# Technical Service Bulletin

## 19 Heating output insufficient (DTC B10D004 and/or B11D501)

19 17 85 2047114/3 April 4, 2017. Supersedes Technical Service Bulletin Group 19 number 17-81 dated March 15, 2017 for reasons listed below.

*Figure 1. Washers installed.*

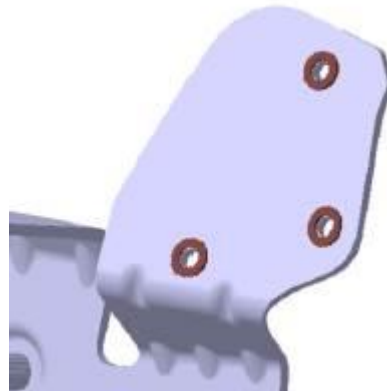
Replace the V50 coolant recirculation pump, use the washers if pump is mounted with screws to the bracket as shown (some models have rubber covered metal band instead).

- N 011 523 21 (3x)

To ensure about 1mm distance between the V50 coolant recirculation pump and its bracket (Figure 1 and 2):
